Subject: Hunter's Lake Timber Sale, proposed

At the request of Lee Fox, I reviewed this proposed sale on the ground and have the following comments.

Subject: Comments on Ross Frid's Hunter Lake Sale  
(Reference 7/29/82 memo)

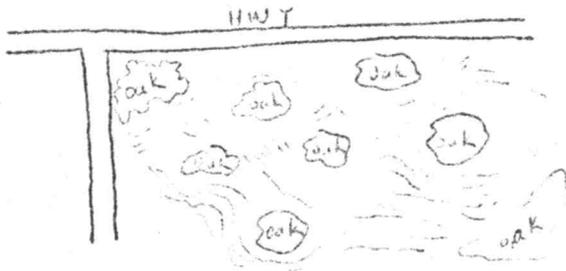
Unit #1 - I understand there may be a chance to increase the size of this unit. I suggest two things. Where oak understory exists, I feel it should be saved and protected from yarding damage. I also suggest you consider this unit for creating an "irregular" shaped opening. I would be glad to work with Lee in establishing the best boundary.

Unit #1 - Cutting in this Block III (Rock Cemetary Unit) at this time should be held to an absolute minimum and only in cases of high risk, e.g. severe budworm areas. I do not concur with the suggestion that we should encourage any existing oak understory. Whenever possible, we are trying to discourage oak in KW habitat; and this area should be no different. Regarding cuts, KW management should always be directed at achieving and maintaining an even
